Groundwater Application Review Summary Form

Application # G- 18484

PUBLIC INTEREST REVIEW FOR GROUNDWATER APPLICATIONS

TO: Water Rights Section Date 08/09/2017
 FROM: Groundwater Section Dennis Orłowski
Reviewer's Name
 SUBJECT: Application G- 18484 Supersedes review of _____
Date of Review(s)

Water-Level Trends in Nearby Wells

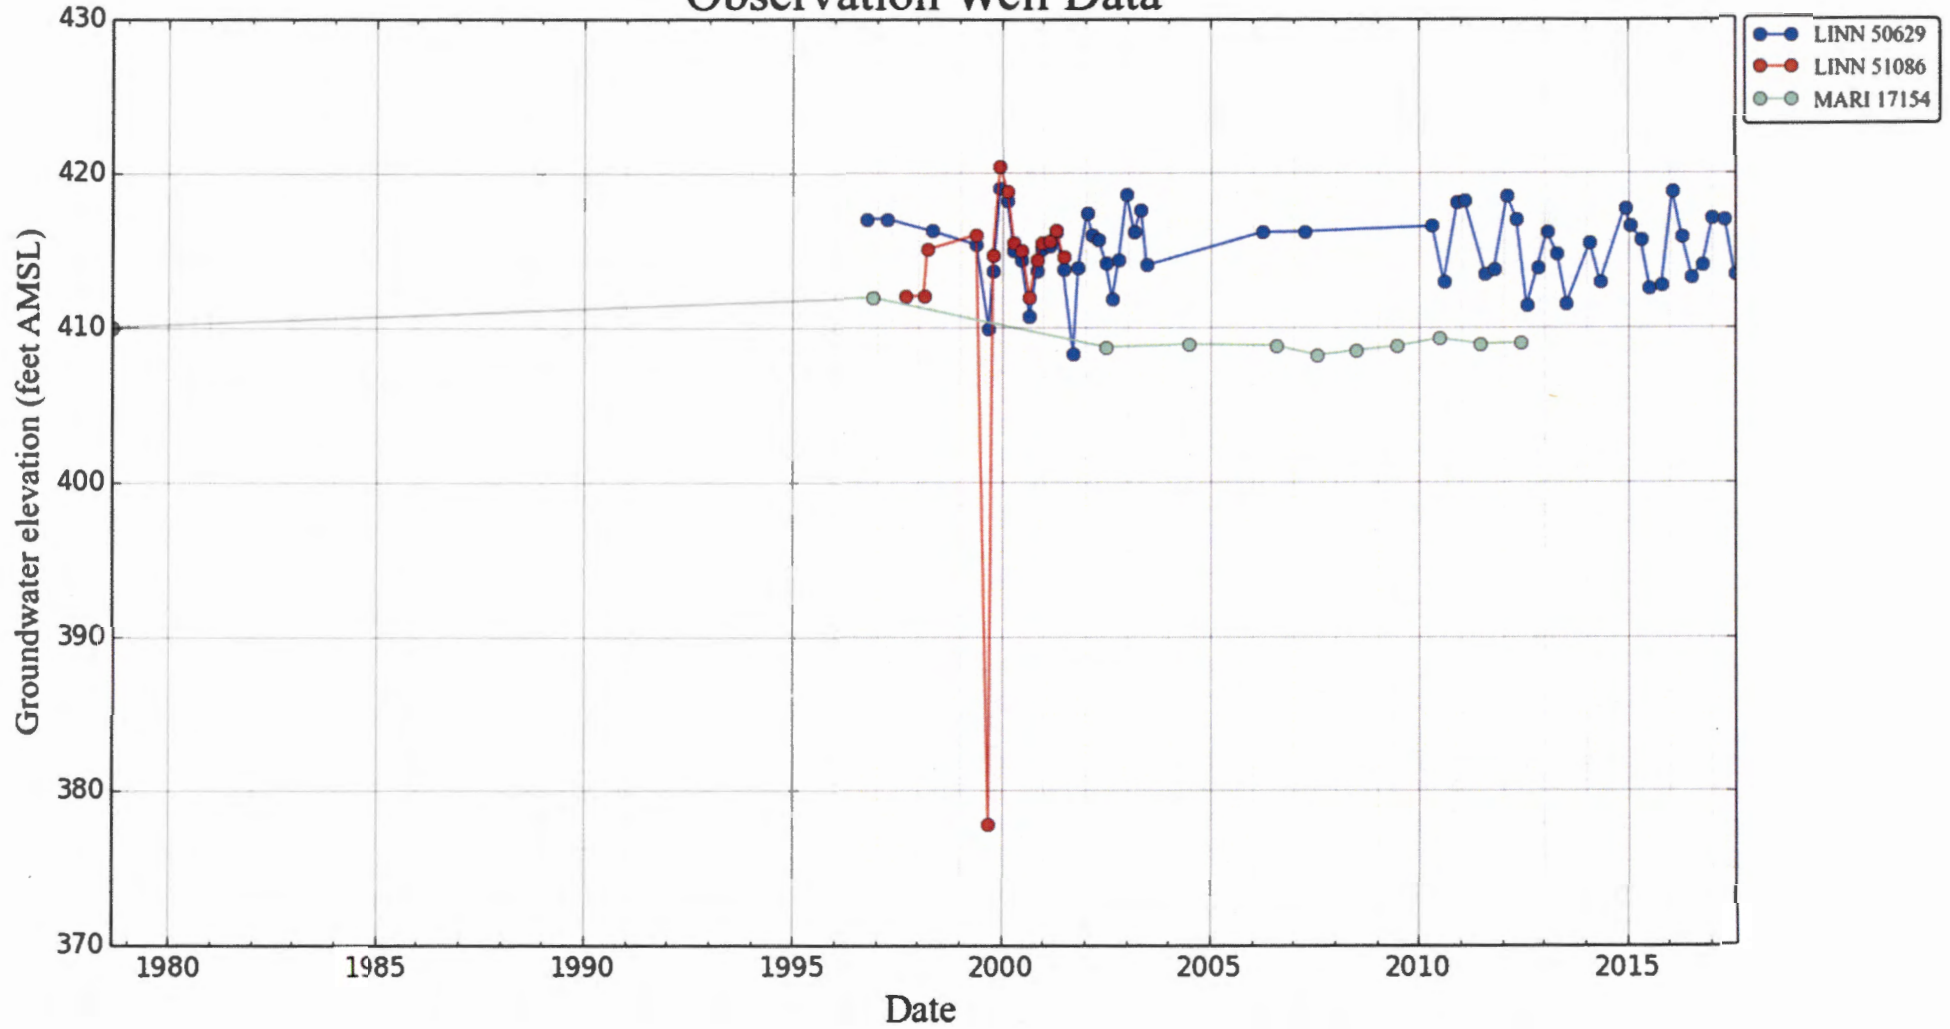
Groundwater level data for the alluvial aquifer in this area is very sparse. However, data available from a few wells show generally stable long-term trends (see attached hydrograph).

Hunt 1999 Stream Depletion Analytical Model Results

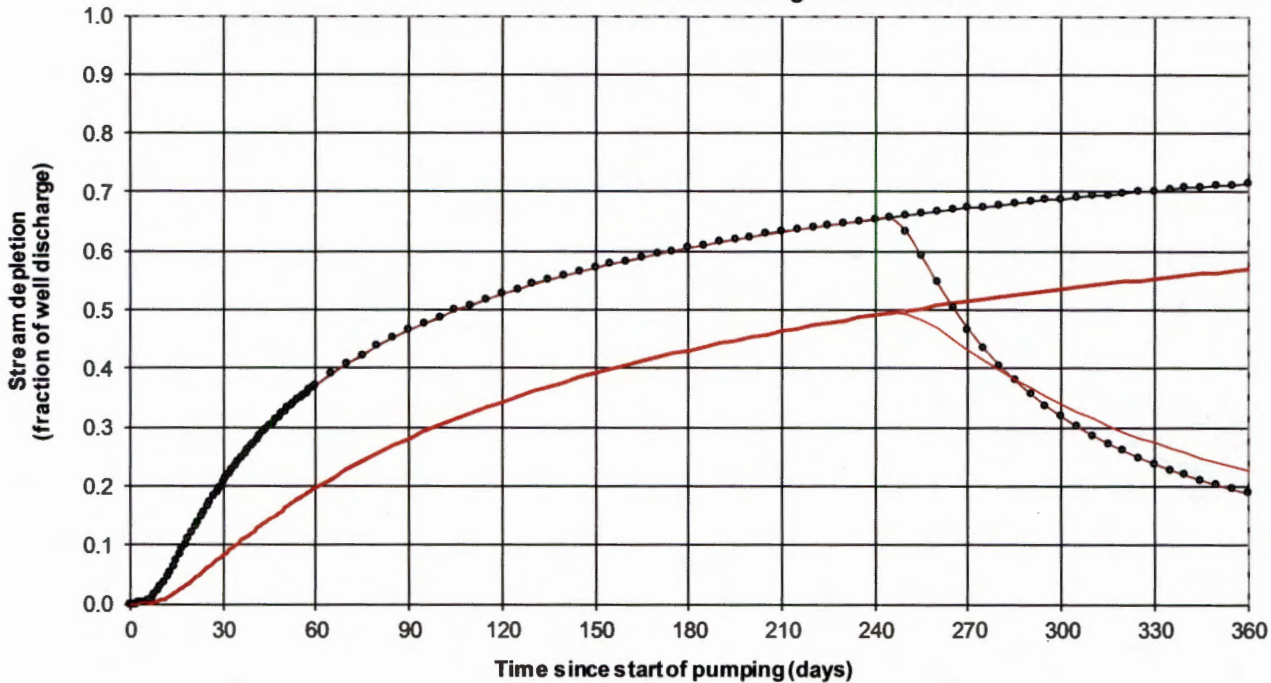
Comments: C3a: The Hunt 1999 analytical stream depletion model was used to estimate pumping interference at 30 days at SW1. Model results indicate that interference is expected to be less than 25% of the maximum allocated pumping rate at 30 days.
